Date: 6/1/03

Subject: Hot-water Generator Concentric Fitting

Figure 1

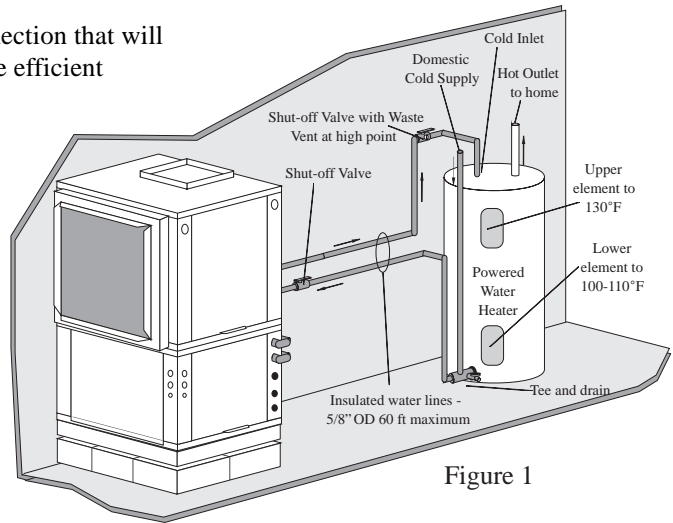
ClimateMaster has discontinued the inclusion of the Hot Water Generator concentric fitting with each unit as a standard item. The intent of this fitting was to provide a convenient means to connect the hot-water generator to the tank. However, in applications where the water contains significant amounts of minerals and the water is not being softened the mineral deposits can collect and restrict the space between the inner and outer tubes of the fitting. Restrictions can render the hot-water generator inefficient, and in some cases, inoperative.

We are now recommending an alternative method of connection that will eliminate the problem described above and allow for more efficient and dependable operation of the hot-water generator. See figure 1 for the alternative method of connection.

The concentric fitting can still be used for applications or areas that do not have significant mineral content. The ClimateMaster part number is S69619804 and can be ordered as required.
